Order Instituting Rulemaking to Implement  
Electric Utility Wildfire Mitigation Plans  
Pursuant to Senate Bill 901

Rulemaking 18-10-007  
(Filed October 25, 2018)

**PROTECT OUR COMMUNITIES FOUNDATION  
COMMENTS ON WILDFIRE MITIGATION PLANS**

#### **Figure 1. 2015-2017 Drivers for PG&E Fire Incidents in HFTD Tiers 2 and 3, and Zone 1**

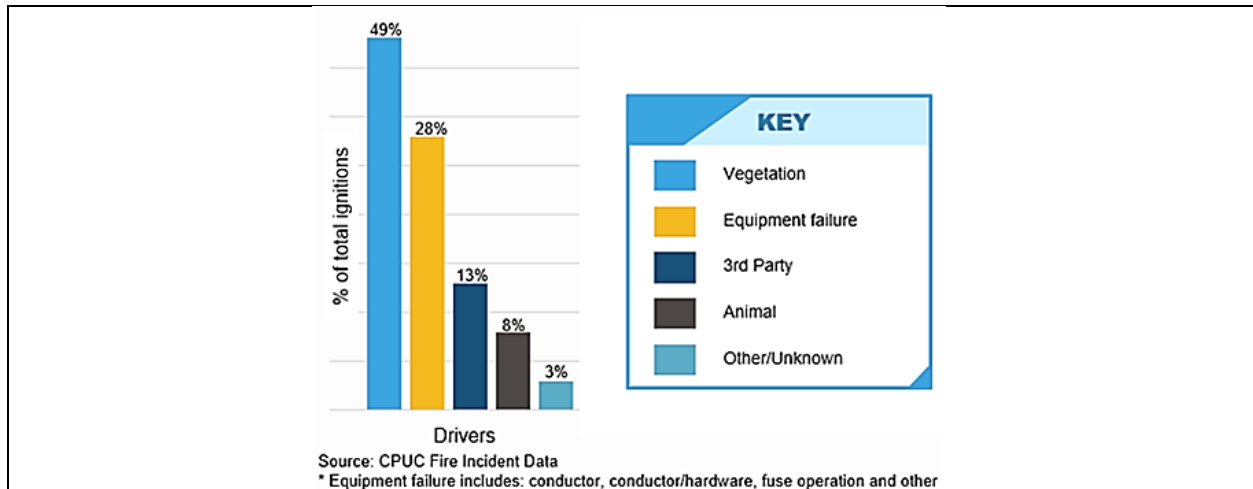
SDG&E's Plan fails to analyze or even report specific causes of 2017 and 2018 fire ignition events. This data is necessary to understand which mitigation actions should be made a priority. In contrast, the PG&E Plan includes detailed CPUC Reportable Ignition Data for its HFTD areas collected from January 1, 2015 through December 31, 2017. The table categorizing the causes of the 2015-2017 ignition events in PG&E HFTD areas is shown in Table 1.<sup>22</sup> About 80 percent of the ignition events were caused by electrified PG&E equipment coming into contact with vegetation or PG&E equipment failures.

This data is critical for understanding where resources need to be focused to reduce fire danger. For example, SDG&E notes that four of the fires in the HFTD were caused by Mylar balloons in the 2015-2017 period.<sup>23</sup> SDG&E also notes that if the territory is expanded to include non-HFTD, the number increases to twelve fires caused by Mylar balloons. PG&E and SCE also identify ignition events caused by Mylar balloons in their respective WMPs. As discussed at the February 13, 2019 WMP workshop, a legislative ban on Mylar balloons would be an effective and low or no cost measure to mitigate this significant source of ignition. However, SDG&E does not include any discussion of this mitigation measure in its Plan and has not taken any action this legislative session to move forward with such action.
